**PCN# 20150902006  
F28M35x Die Revision Change  
Final Change Notification / Sample Request**

<b>PCN Number:</b>	20150902006			<b>PCN Date:</b>	09/10/2015
<b>Title:</b>	F28M35x Die Revision Change				
<b>Customer Contact:</b>		PCN Manager	<b>Dept:</b>	Quality Services	
<b>Proposed 1<sup>st</sup> Ship Date:</b>		12/10/2015	<b>Estimated Sample Availability:</b>		Date provided at sample request.
<b>Change Type:</b>					
<input type="checkbox"/>	Assembly Site	<input type="checkbox"/>	Assembly Process	<input type="checkbox"/>	Assembly Materials
<input checked="" type="checkbox"/>	Design	<input type="checkbox"/>	Electrical Specification	<input type="checkbox"/>	Mechanical Specification
<input type="checkbox"/>	Test Site	<input type="checkbox"/>	Packing/Shipping/Labeling	<input type="checkbox"/>	Test Process
<input type="checkbox"/>	Wafer Bump Site	<input type="checkbox"/>	Wafer Bump Material	<input type="checkbox"/>	Wafer Bump Process
<input type="checkbox"/>	Wafer Fab Site	<input type="checkbox"/>	Wafer Fab Materials	<input type="checkbox"/>	Wafer Fab Process

This notification is to announce a die revision and datasheet change to the devices listed in the Product Affected Section of

Sample product shipping label to indicate die rev location (not actual product label)

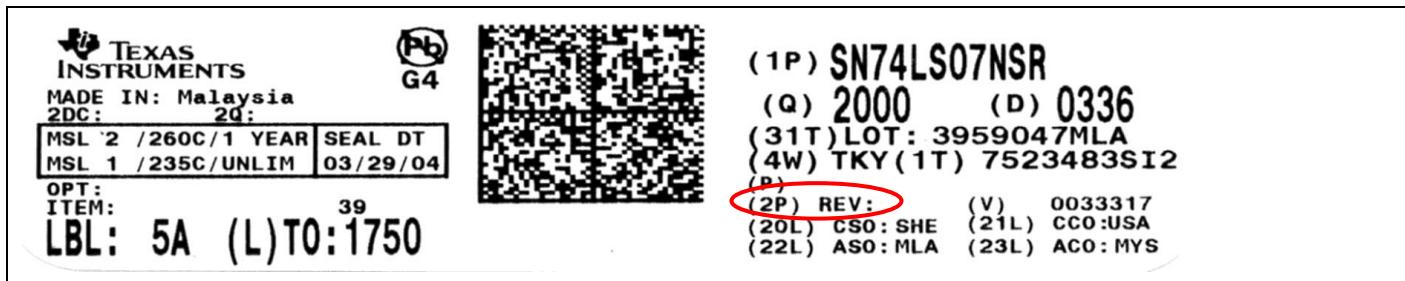
Die Rev designator will change as shown in the table and sample label below:

Current	New
Die Rev [2P]	<b>Die Rev [2P]</b>
<b>B</b>	<b>E</b>
